# Central Nebraska Veterans Home

## Addendum 3

Kearney, Nebraska  
1404

Date Issued: December 8, 2015  
Bid Date: December 17, 2015

**GRATE INLET DETAIL**

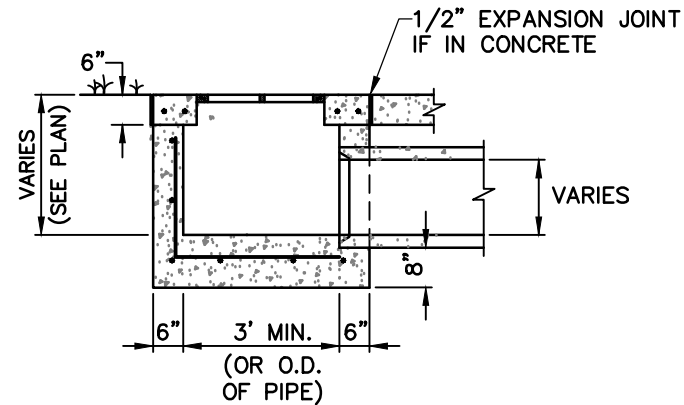
<b>Addendum 3 – 50</b>	<b>Sheet C3.17 – Storm Sewer Details</b> Refer to Notes on Detail 4, “Roof Drain Typical Layout”; Add “4. Special bedding material for roof drain piping is not required. However, compaction of backfill material must meet requirements of storm sewer specifications to prevent settling of trenches”.
<b>Addendum 3 – 51</b>	<b>Sheet C3.18 – Storm Sewer Details</b> Refer to SKC3 as attached to this Addendum 3 for revisions made to Detail 1, “Grate Inlet Detail”.
<b>Addendum 3 - 52</b>	<b>Sheet C4.04 - Water Main Details</b> Refer to Detail 2, “Encasement Pipe Details”; Sand may be utilized in lieu of grout as indicated to fill voids between carrier pipe and encasement pipe. Grout end seals are still required.
<b>Addendum 3 - 53</b>	<b>Sheet C4.05 - Water Main Details</b> Refer to Note 3, Detail 4, “Fire Hydrant Detail”; All fittings and valves are required to be restrained, however pipe joints are not required to be restrained. Restrain valve to tee as shown in detail.

SKC4

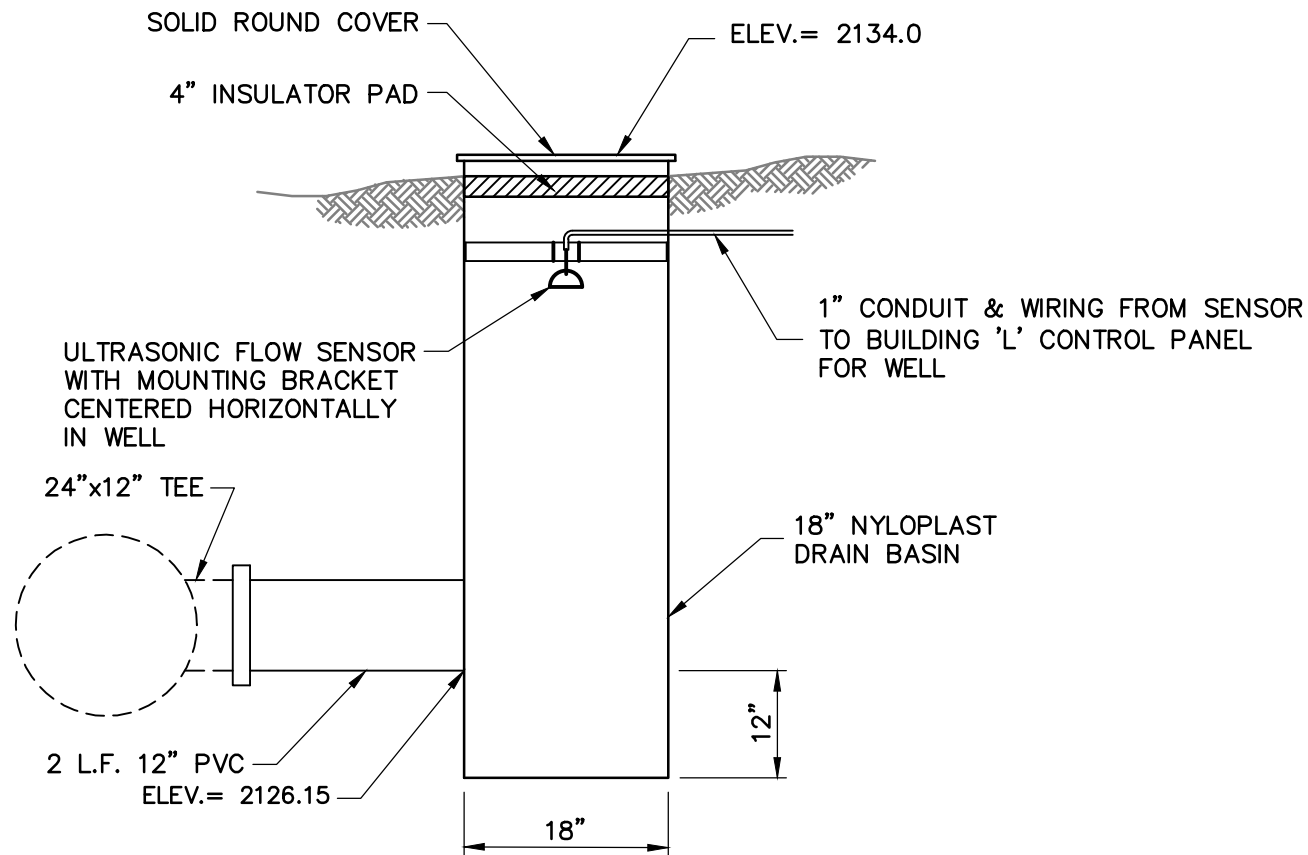
<b>Addendum 3 - 54</b>	<b>Sheet C4.07 - Irrigation Meter and Wet Well Details</b> Refer to SKC4 as attached to this Addendum 3 for new Detail 3, “Pond Water Level Sensor Structure”.
<b>Addendum 3 - 55</b>	<b>Sheet C5.05 - Sanitary Sewer Details</b> Refer to Detail 1, “Encasement Pipe Details”; Sand may be utilized in lieu of grout as indicated to fill voids between carrier pipe and encasement pipe. Grout end seals are still required.
<b>Addendum 3 – 56</b>	<b>Sheet L4.02 – Pond Grading Plan</b> Refer to Sketch SKL1 and SKL2 for alignment and invert elevations for the 6” diameter subdrain pipe below the fire access lane pavers.
<b>Addendum 3 - 57</b>	<b>Sheet L5.01 – Typical Site &amp; Landscape Details</b> Refer to Sketch SKL3 for revisions to Detail 1, Fire Access Lane, indicating condition of subdrain pipe and geotextile fabric when located within pipe trench.
<b>Addendum 3 – 58</b>	<b>Sheet A1.G.01 – Floor Plans – Building G – Hub &amp; Walkways</b> Add detail 7/A1.G.01 TYP. FLOOR EJ DETAIL AT EJC-3 on attached SKA3.

1. BASIN, COVER, INSULATOR PAD, AND PIPING BY POND OUTLET PIPE INSTALLER.
2. ULTRASONIC LEVEL INDICATOR, MOUNTING BRACKET, CONTROLS, PANELS, CONDUIT, AND WIRING BY WELL/PUMP INSTALLER.
3. PROVIDE CONTROL PANEL IN BUILDING 'L' (REFER TO DETAIL 3 SHEET E2.K.01 FOR PANEL LOCATION IN BUILDING) WITH HAND-OFF-AUTO SELECTOR SWITCH AND PLC CONTROLLER TO ACCEPT ULTRASONIC CONTROL INDICATOR AND ALLOW USER SET POINTS FOR ALL OPERATIONS.

M6.03

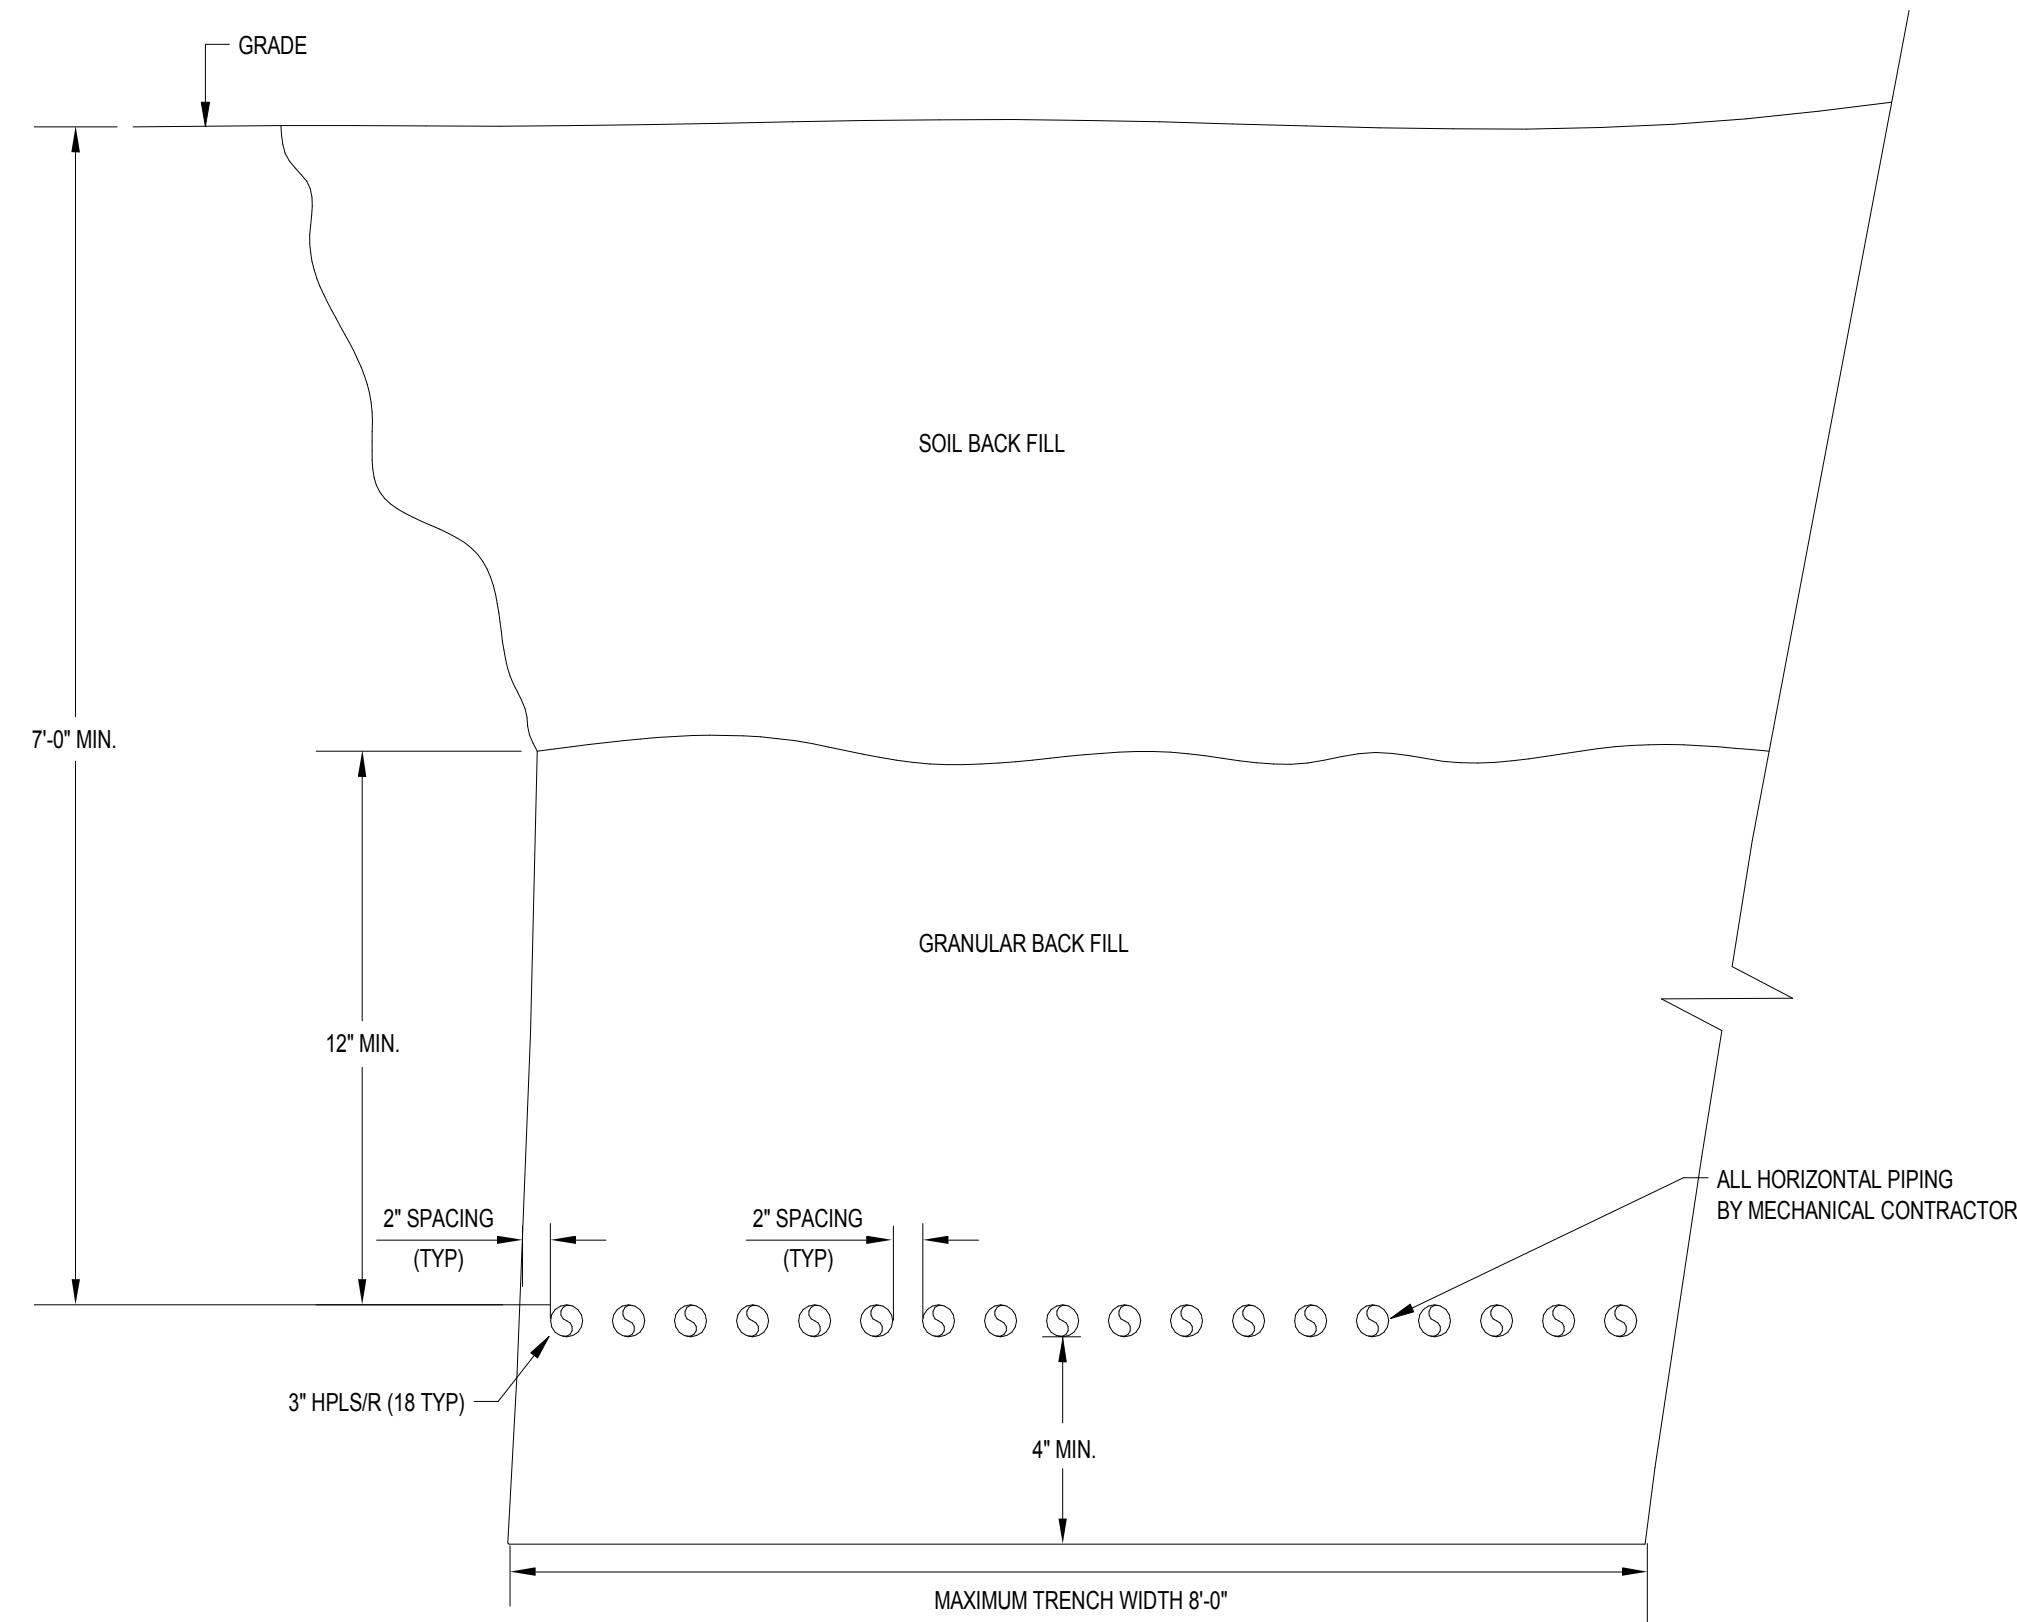
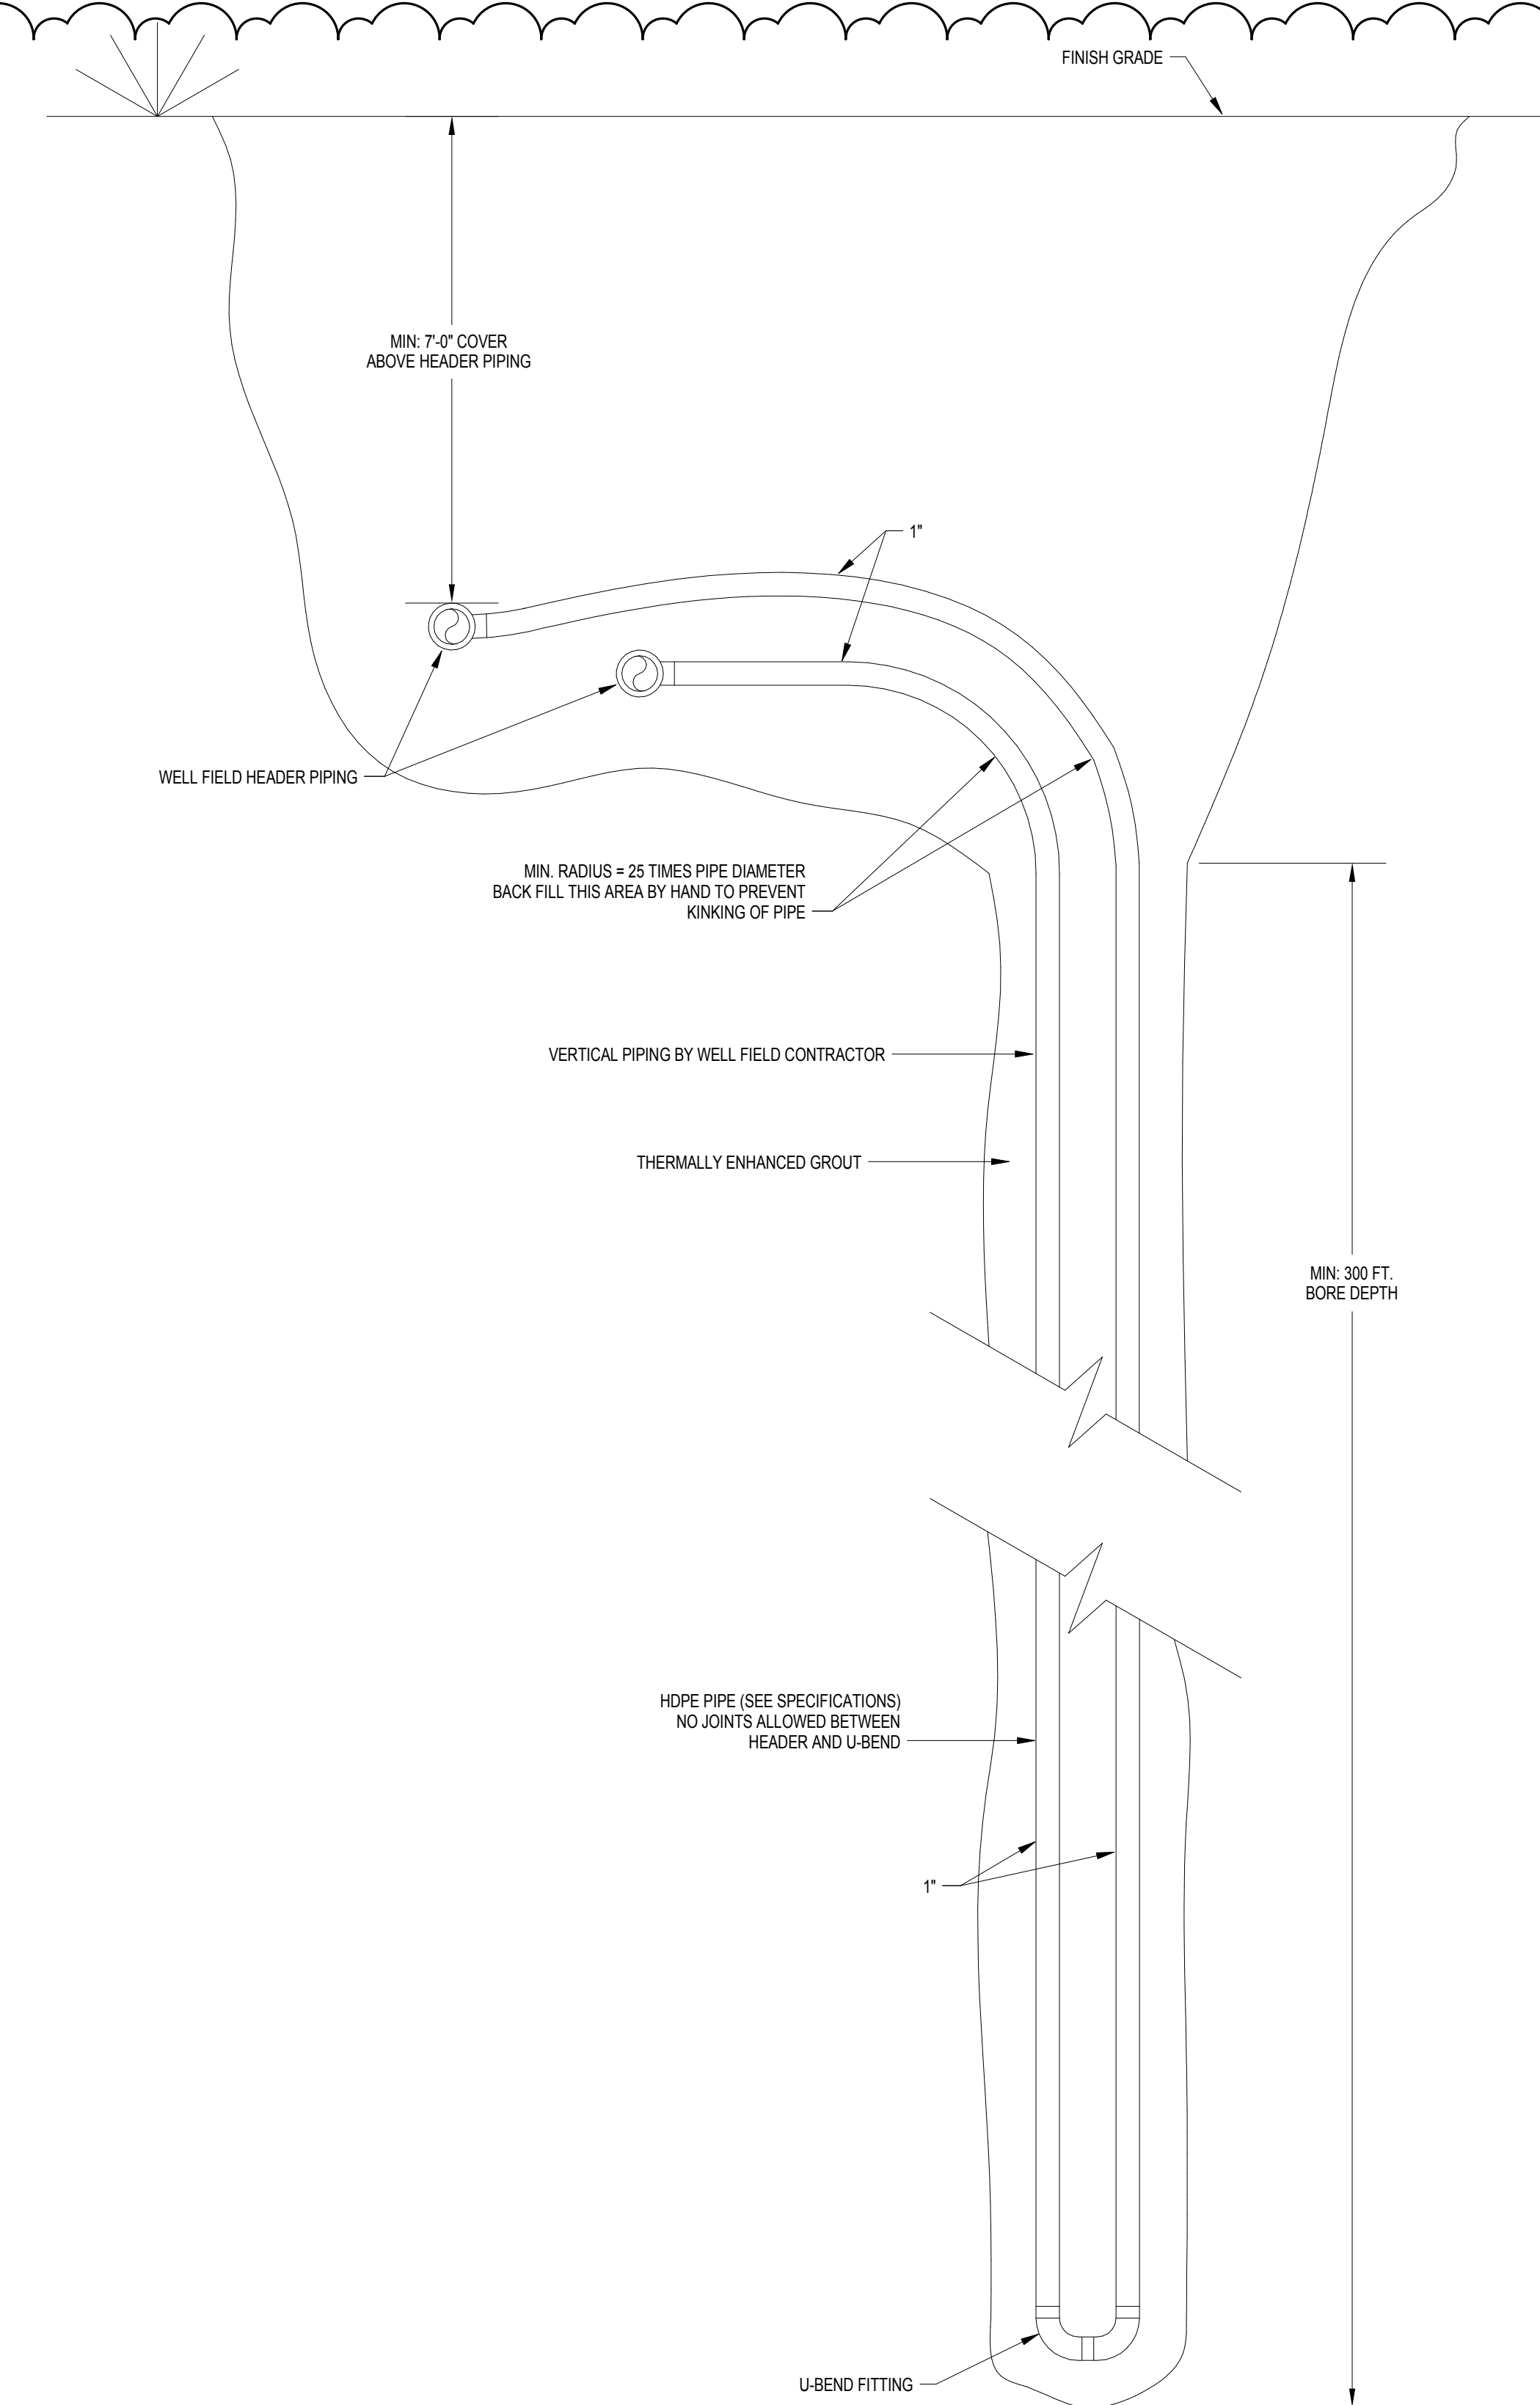
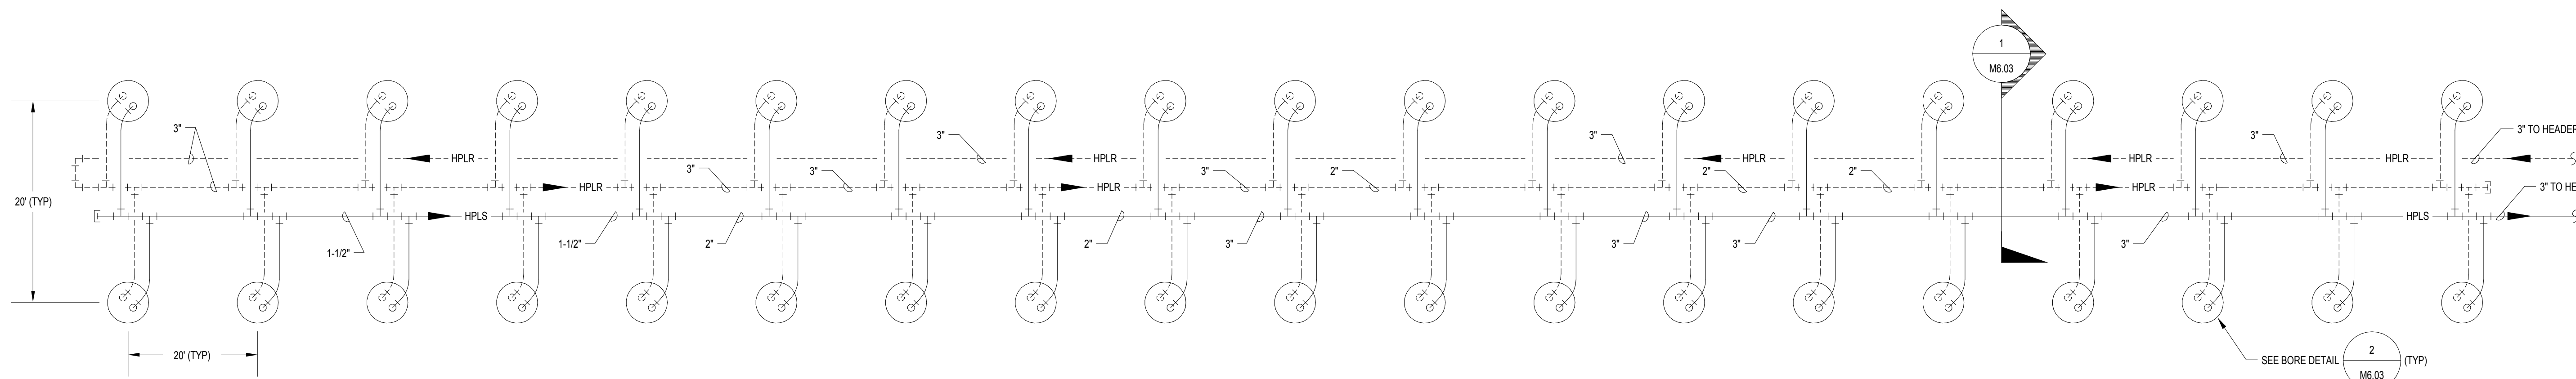
<b>Addendum 3 - 73</b>	<b>Sheet M6.01 – Mechanical Details</b> Detail 12, Sheet M6.01 Energy Recovery Unit Detail Delete housekeeping pad where installed on mechanical mezzanines. Housekeeping pad remains where installed in Building J. Housekeeping pad not required where installed on Roof.
<b>Addendum 3 - 74</b>	<b>Sheet M6.03 – Mechanical Details</b> Multiple revisions on sheet regarding geothermal heat pump details. See revised sheet.
